South Texas Project Electric Generating Station 4000 Avenue F – Suite A Bay City, Texas 77414

February 10, 2010
U7-C-STP-NRC-100036

South Texas Project
Units 3 and 4
Docket Nos. 52-012 and 52-013
Response to Request for Additional Information

Attached are the responses to the NRC staff questions included in Request for Additional Information (RAI) letter numbers 299 and 302 related to Combined License Application (COLA) Part 2, Tier 2, Sections 3.7.1, 3.7.2 and 3.8.4.

Figure 03.07.01-20h: Resultant Out-of-Plane Shear V13 Diagram
(Using Lower Range Site-Specific Spring Constants)

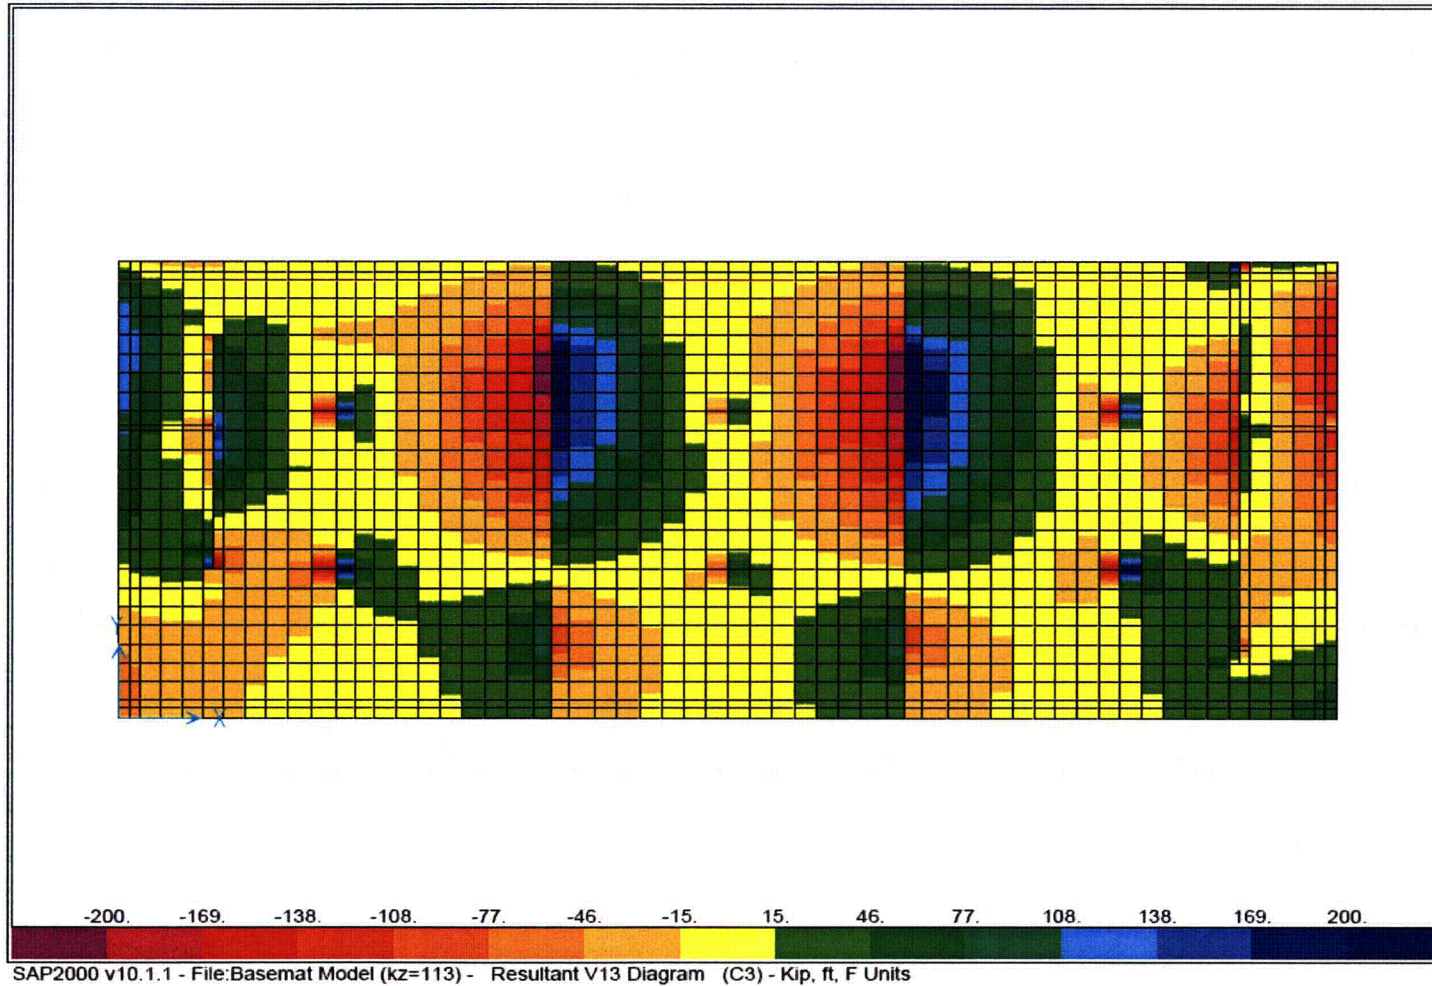
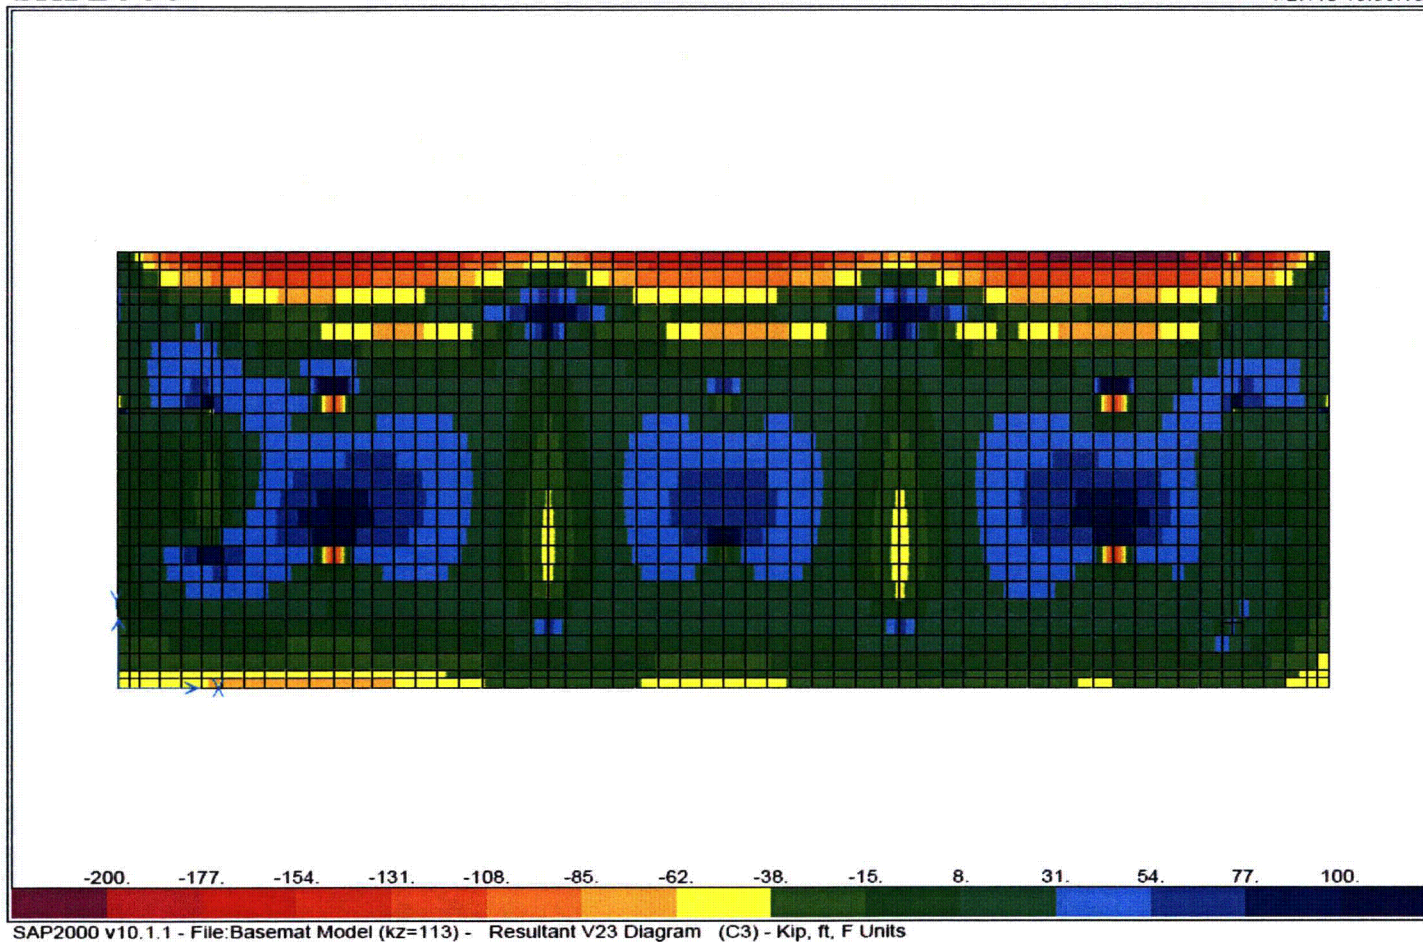
- (2) In the response to RAI 03.07.01-7, the applicant stated that "*The spring constant values are provided only for the Reactor Building in the DCD. Therefore, a comparison of the spring constant values is provided only for the Reactor Building.*" This justification for not evaluating the effect of site-specific shear wave velocity on the Control Building (CB) foundation design is not acceptable. The applicant is requested to further justify that the design of the CB foundation at the STP site would still be bounded by the standard plant CB design.

As noted in part (2a) of this response, the calculated STP site-specific soil spring constants for the upper range and best estimate cases are the same as, or higher than, the best estimate soil spring constants used for the standard design. Higher soil spring constants at the STP site will result in mat design forces smaller than those used for the ABWR CB design. The lower range site-specific soil spring constants are lower than the best estimate DCD spring constants. However, even with lower range site-specific spring constants, the ABWR CB mat design is adequate for the STP site for the following reasons:

- Considering the size and geometry of the CB, arrangement of the exterior and interior shear walls, thickness of the shear walls (39 inch exterior walls and 63 inch interior walls), and the mat thickness (i.e. 118 inches), the CB mat design is quite rigid and not so sensitive to spring constant values. This can be seen from the parametric study results presented in Figures 03.07.01-20a through 03.07.01-20i provided with this response.

Figure 03.07.01-20a shows the layout of the mat and the shear walls of a structure with very similar arrangement to that of the DCD CB. The model used for this parametric study is a three dimensional finite element model. This model was analyzed twice for the total dead load of the structure along with significant seismic moment about the X-axis (along East-West), once with DCD best estimate spring constants and the second time with lower bound site-specific spring constants. Figures 03-07-01-20b through 03-07-01-20e present contour plots of the resulting out-of-plane moments and shears when using DCD spring constants. Figures 03-07-01-20f through 03-07-01-20i present contour plots of the resulting out-of-plane moments and shears when using lower range site-specific spring constants. Comparison of the resulting out-of-plane moments and shears from these two cases show that there is no significant change in mat design forces.

Figure 03.07.01-13a

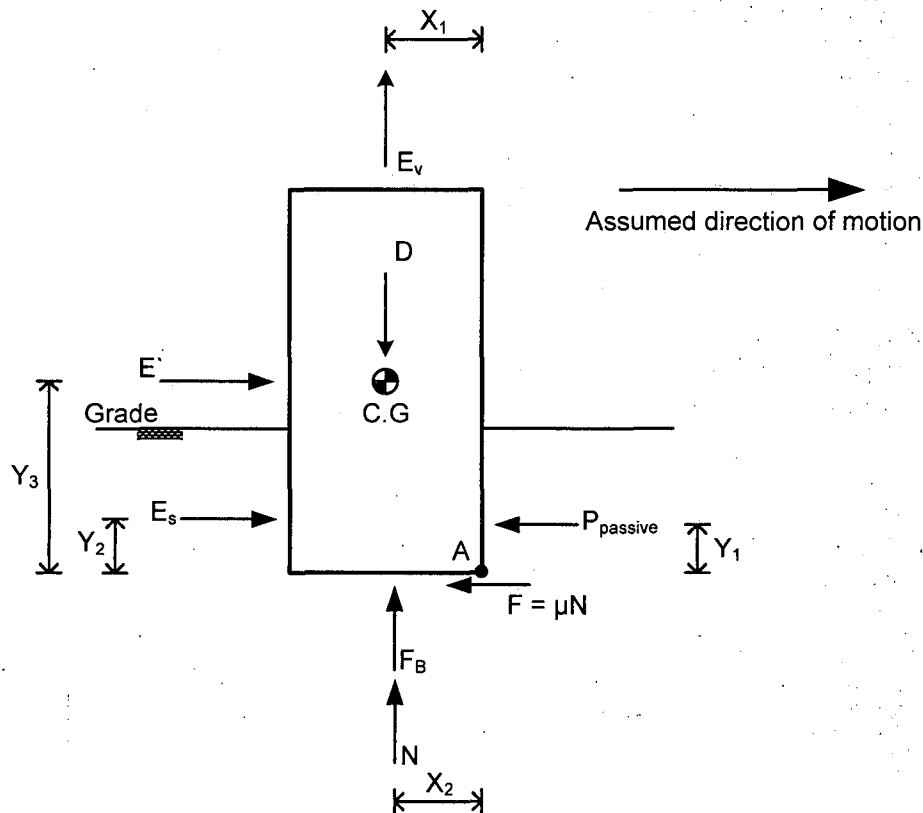
2. The response to item (c) of RAI 03.07.02-1 indicated that non-Category I structures with the potential to interact with Category I structures have not yet progressed to a point where sliding and overturning potential as a result of the SSE can be evaluated. However, as identified in SRP guidance 3.7.2I.8., the staff must review the applicant's seismic design of these non- Category I structures. As such, the applicant is requested to provide in the FSAR factors of safety against sliding and overturning including the basis of coefficient of friction used in the analysis during an SSE for Turbine Building, Radwaste Building, Service Building, Control Building Annex, and Plant Stack.

- Sliding and overturning evaluations are performed as shown in Figure 03.07.03-13a.
- Coefficient of friction for sliding evaluations for the four buildings shall be based on site-specific soil conditions.
- For simultaneous application of seismic forces in three directions the 100%, 40%, 40% combination rule as shown below will be used:

Figure 3H.6-40: SAP Finite Element Model for UHS and RSW Pump House Design

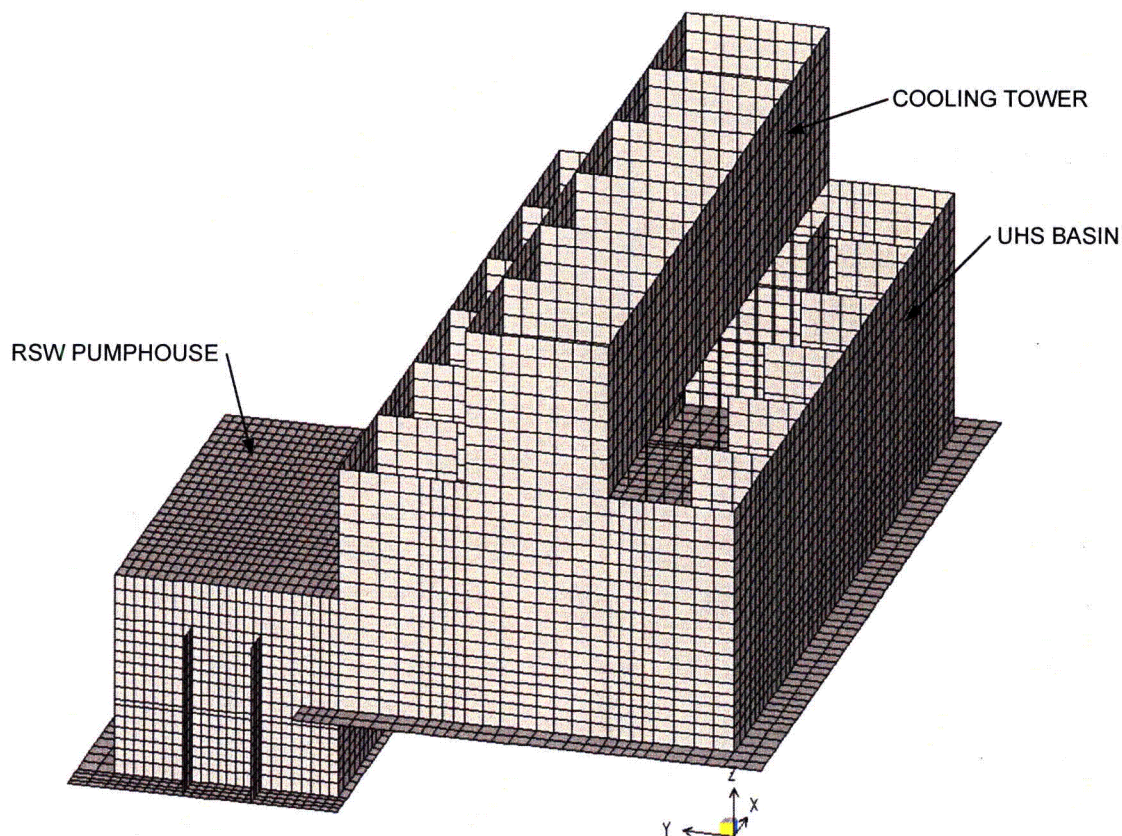
1. The finite element model referenced in Figure 3H.6-40 (this figure is not yet available in the response to RAI 03.07.01-13).
2. Method used to model the backfill material in the SSI analysis.
3. Method used to incorporate the ground water effects in the SSI analysis.
4. The analysis method used to obtain the seismic forces and moments for design evaluations.
5. The analysis method used to model concrete cracking.
6. The analysis method used to assess the effects of soil separation from the walls.

1. Figure 3H.6-40 was provided as part of the Supplement 1 response to RAI 03.07.01-13 (see letter U7-C-STP-NRC-090208 dated 11/19/2009) and for convenience is reproduced below. For additional information and figures for the Soil-Structure Interaction (SSI) analysis model of the Ultimate Heat Sink (UHS) and Reactor Service Water (RSW) Pump House, please see the response to RAI 03.07.02-16 submitted concurrently with this response.

Figure 3H.6-15: SASSI2000 Model of UHS and RSW Pump House

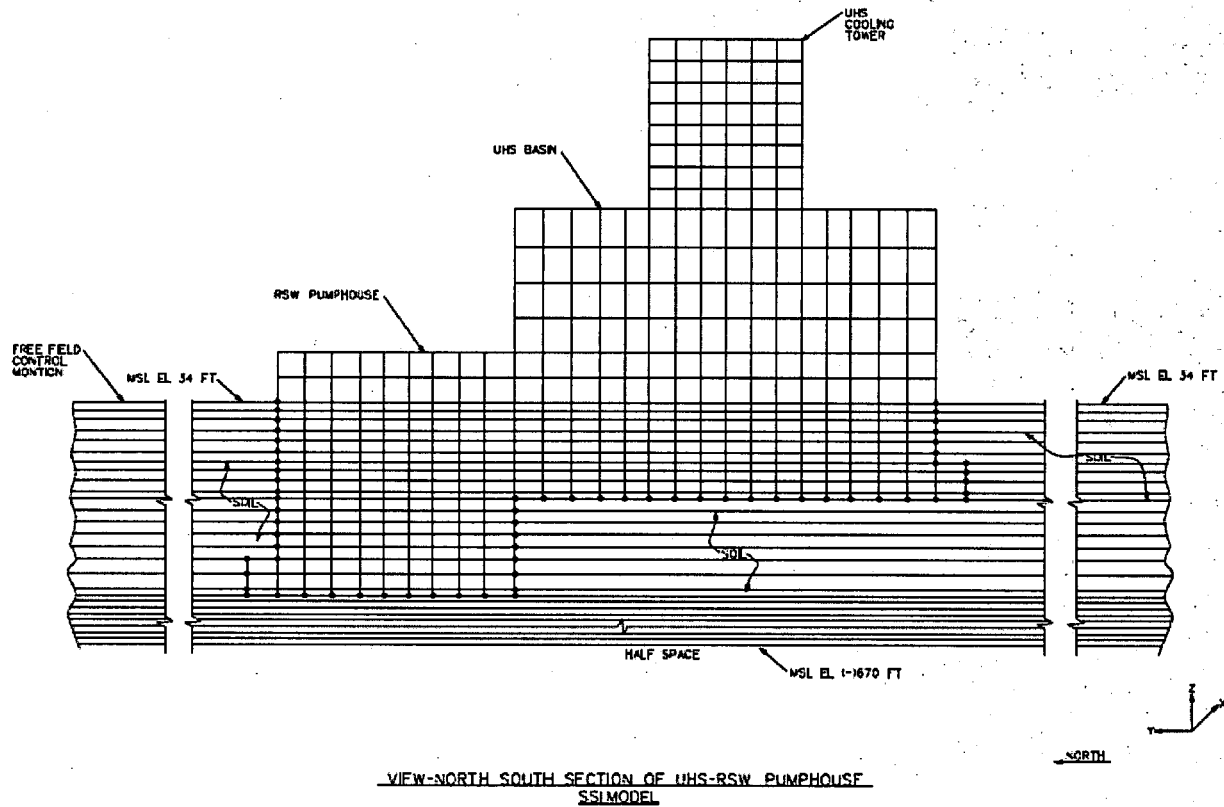
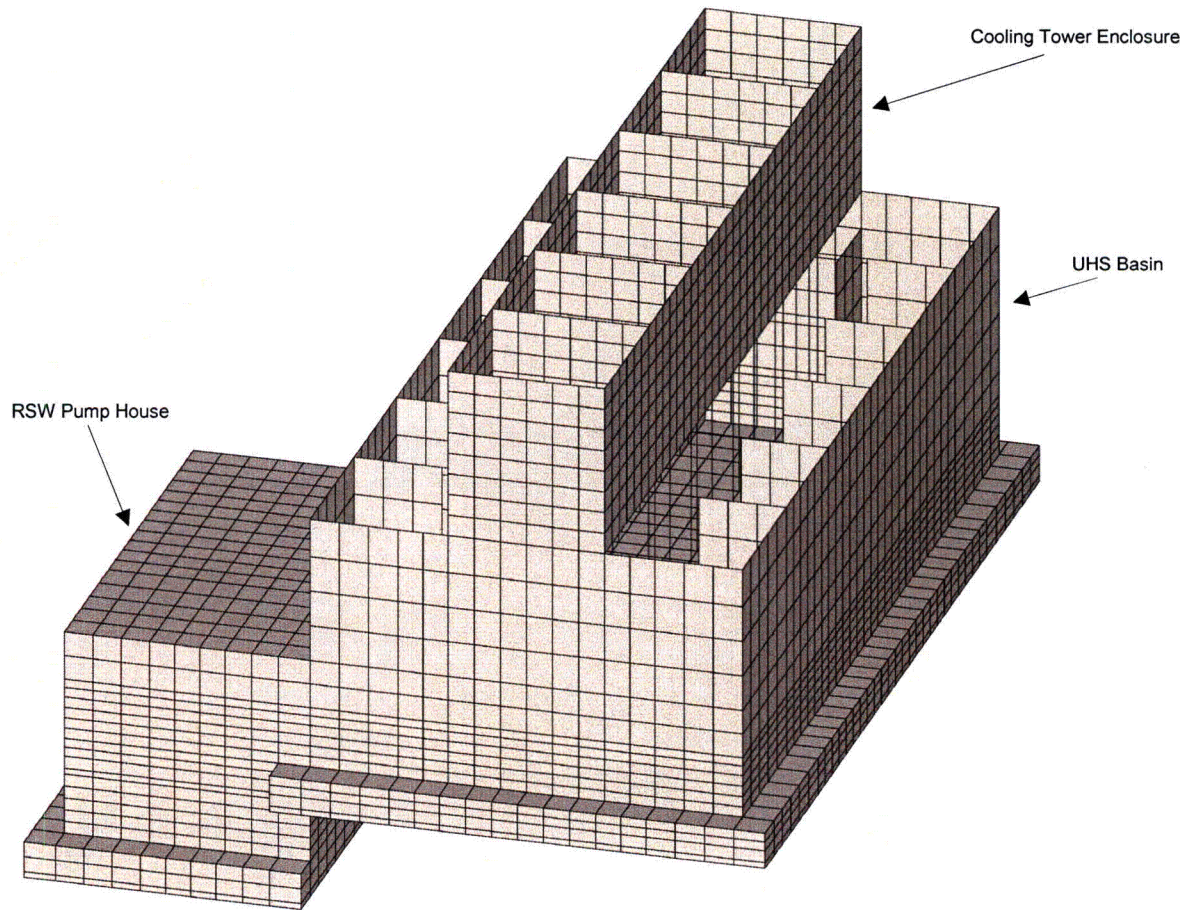
7. A figure showing the finite element model of the structure in relation to the layered soil system.
8. A description of how the ground water effects were treated in the SASSI2000 model.

7. Figure 3H.6-15 showing the north-south cross-section of the three-dimensional finite element model of both structure and soil layers was provided as part of the Supplement 1 response to RAI 03.07.01-13 (see letter U7-C-STP-NRC-090208, dated 11/19/2009) and for convenience was reproduced in part 3 above. For additional information and figures, please see the response to RAI 03.07.02-16 submitted concurrently with this response.

Figure 3H.6-138: Broadened Horizontal FRS for RSW Piping Tunnels

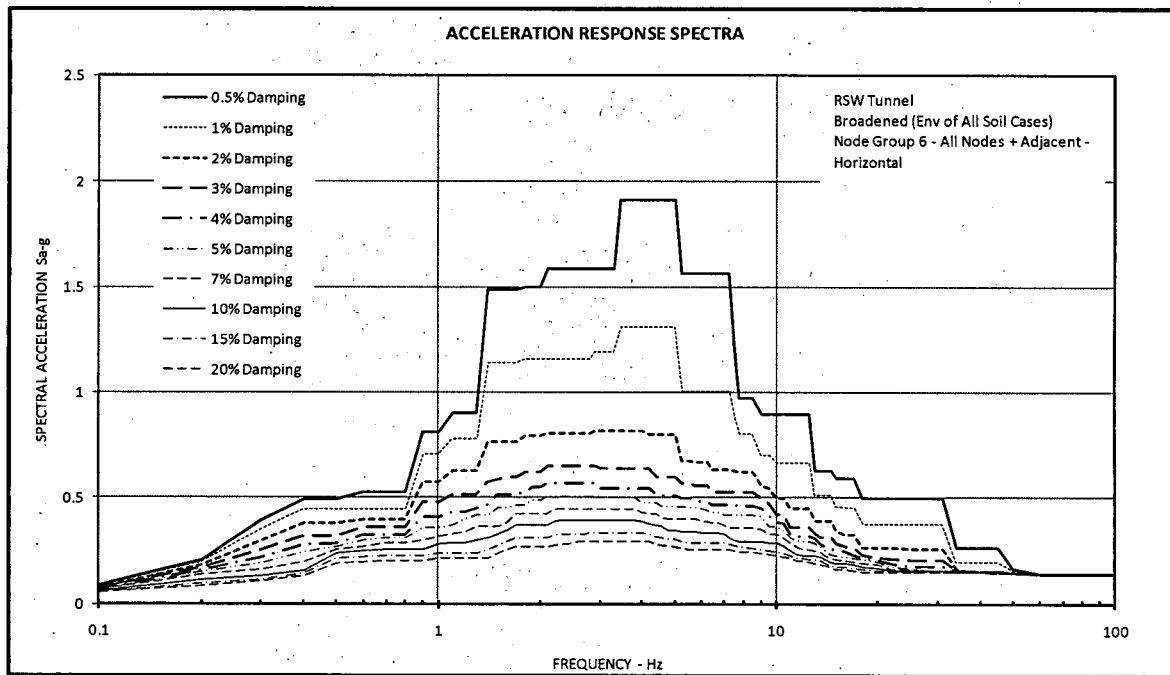
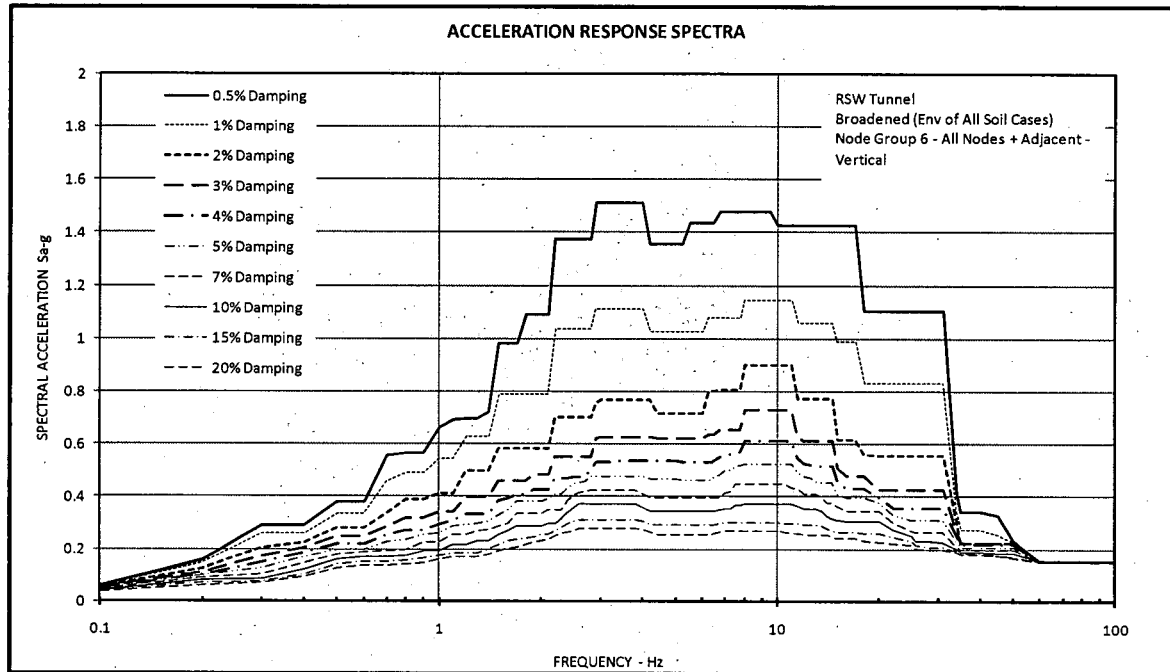
1. A description of the equivalent static analysis method used for the RSW piping tunnel.
2. A description of how the seismic and static loads were calculated and applied to the model. Show the model and boundary conditions including the soil springs used in the analysis.
3. A description of the type of strains (tensile or compression) were calculated in the RSW piping tunnel.
4. A description of how both axial strain and transverse shear demands were considered in the analysis of the RSW piping tunnel.
5. A description of how the concrete elements of the RSW piping tunnel were determined to be rigid so that there are no in-structure amplifications.
6. Describe the SSI analysis from which the accelerations are obtained to establish the SSI forces for the analysis of the RSW piping tunnel (see the last bullet in Section 3H.6.6.2.2).

In order to quantify the in-structure amplification and ensure that the use of 0.21g ZPA adequately accounted for in-structure amplification, a two-dimensional SSI analysis of the RSW tunnel is performed. Attached Figures 3H.6-138 and 3H.6-139 show the resulting amplified response spectra for all the walls and slabs of the tunnels. As can be seen from these figures, the amplified ZPA of these response spectra are less than 0.21g ZPA acceleration used for the design of tunnels' walls and slabs.

Figure 3H.6-40: SAP Finite Element Model for UHS and RSW Pump House Design

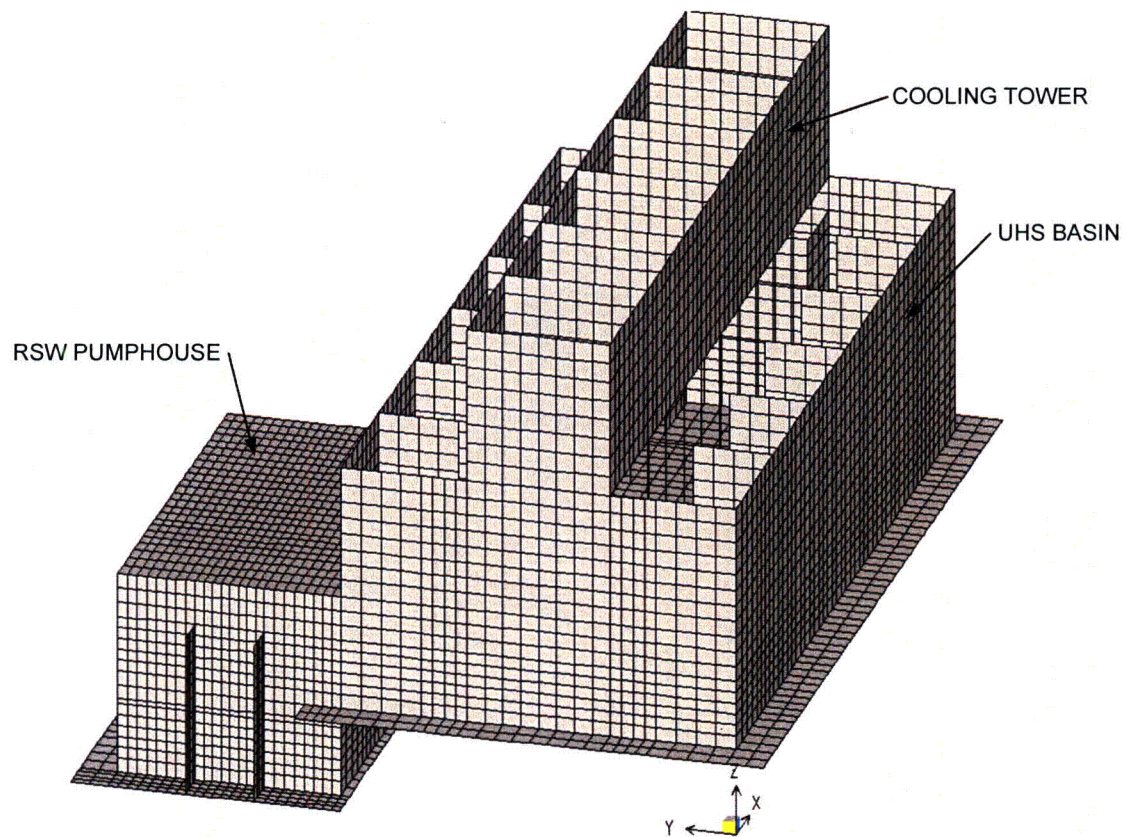
1. In the response to Item 2 of RAI 03.07.01-4, the finite element model of the UHS basin and RSW Pump House was not provided in Figure 3H.6-40 (this figure was supposed to be part of the response to RAI 03.07.01-13). The applicant is requested to ensure this information be part of Figure 3H.6-40, including a plot showing the basement slab and soil-retaining wall mesh configuration and grid sizes. The response to Item 2 of RAI 03.07.01-4 also states that, ***"The model mesh size is detailed enough to model the principal features of the structure and transmit a frequency of at least 33 Hz."*** The applicant is requested to a) provide the criteria and quantitative basis to show that the element sizes are sufficiently small to transmit frequencies of up to 33 Hz for the three soil cases; and b) provide a justification that the aspect ratio of the elements is sufficiently small as not to affect the solution accuracy.

1. Figure 3H.6-40 has been provided as part of the Supplement 1 response to RAI 03.07.01-13 (see letter U7-C-STP-NRC-090208 dated 11/19/2009) and for convenience is reproduced below. Note that this figure provides the Finite Element Model (FEM) used for design of the ultimate head sink (UHS) and reactor service water (RSW) pump house. In this FEM, the basemat is represented by shell elements, whereas in the FEM model for the soil-structure interaction (SSI) analysis (see Figure 3H.6-15a) the basemat is represented by solid elements. Solid elements are required for proper modeling of interaction between the soil and the structure in the SSI analysis.
